ADDENDUM NO. 1
TO
CITY OF AUBURN, MAINE
2022 MPI PROJECT – MT. AUBURN AVENUE RECONSTRUCTION
May 20, 2022

This addendum amends and /or supplements the bid documents as indicated below. Only these items alter the bid documents. Any verbal discussions or responses are hereby declared null and void. Please acknowledge this addendum on the attached Bid Form.

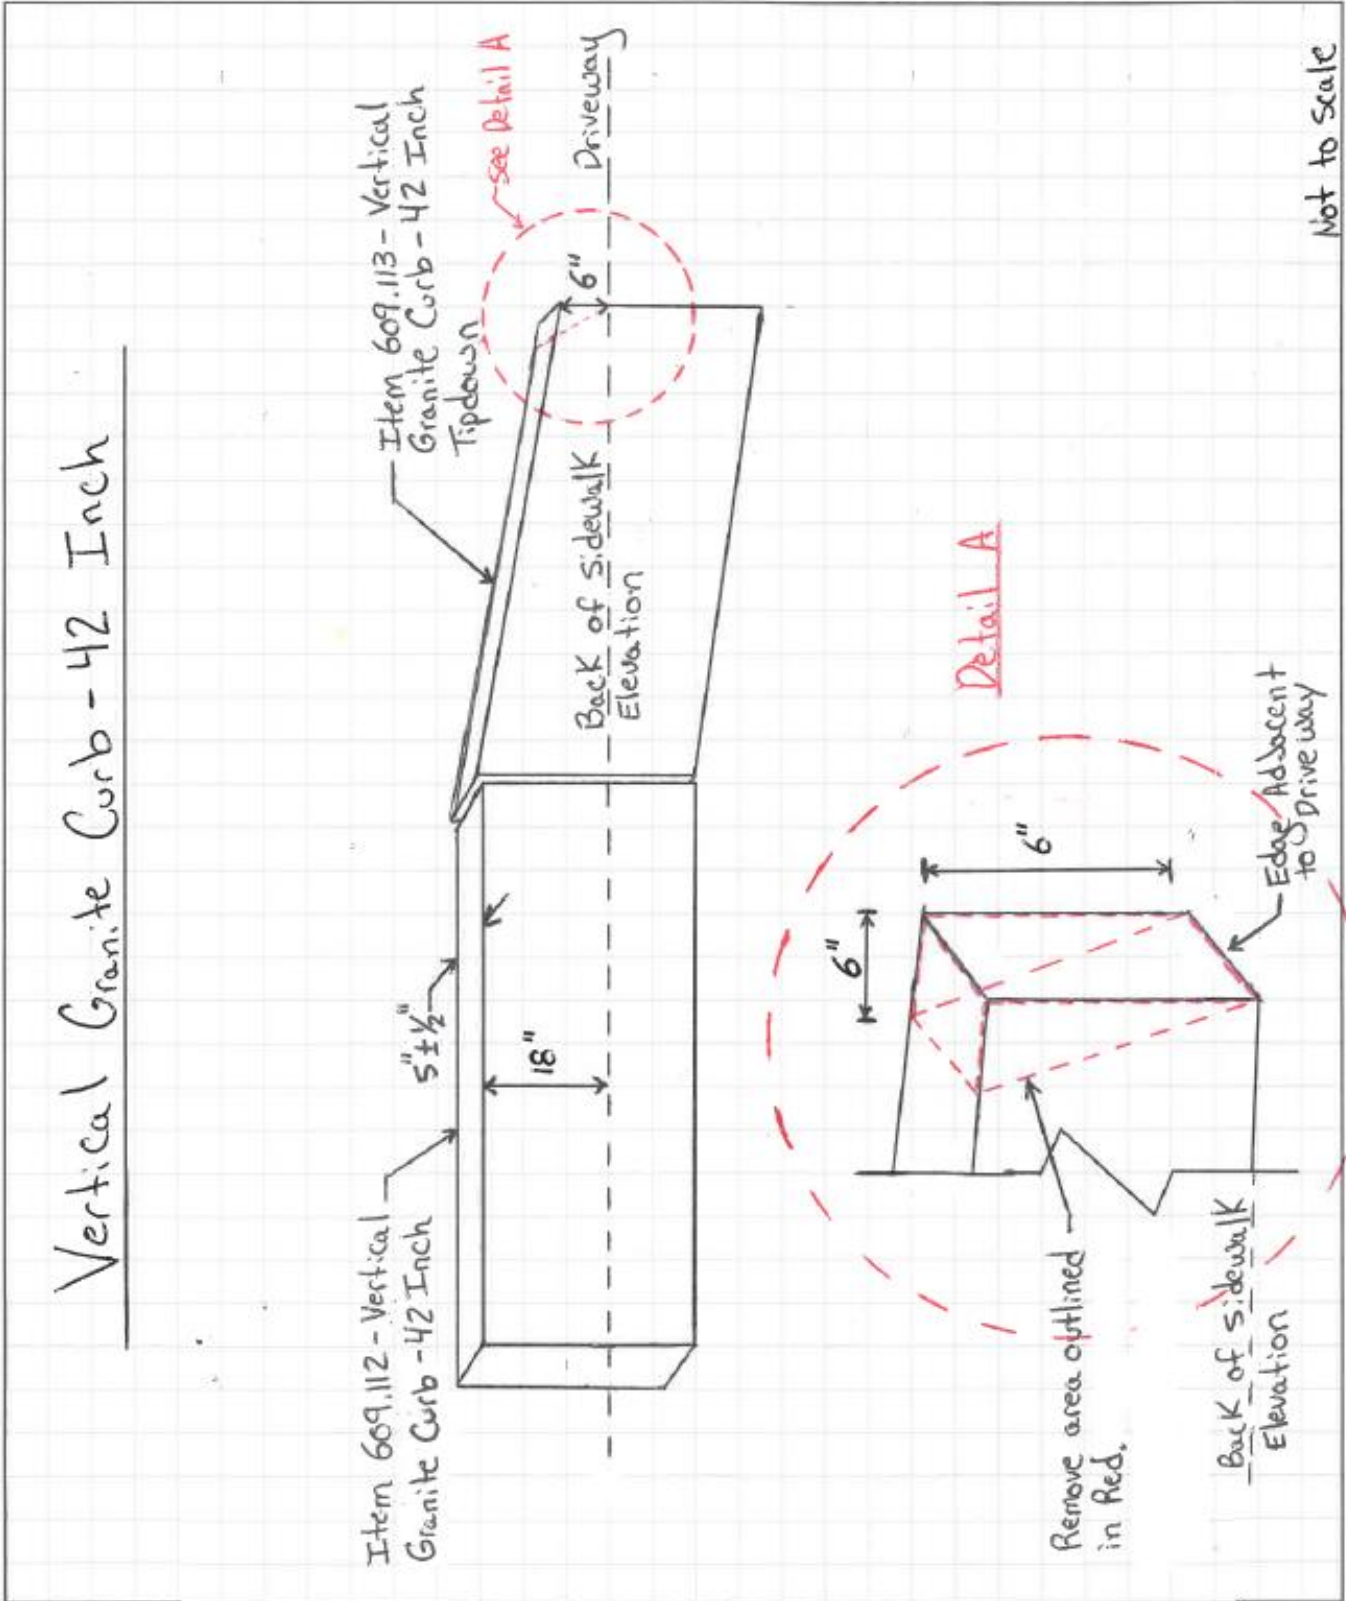
16. Question: Can you please provide additional clarification on items 609.112 and 609.113? What is the width of the curb? Can we get a detail for the chamfer on item 609.113?

Item 609.113, Special vertical granite curb – 42” – Tipdown shall taper the reveal from 18” to 6” and have the corners of the outside curb chamfer. See detail for additional information regarding this item.

- a. Answer: The curb width shall be standard 5" +/- 0.5" per the standard details. An additional detail has been provided in this addendum to clarify how this item is to be installed.

Payment for item 609.112 and 609.113 shall be made by the linear foot complete in place. Cutting the curb and chamfering the corners of the curb as noted within the contract documents shall be incidental to these items.
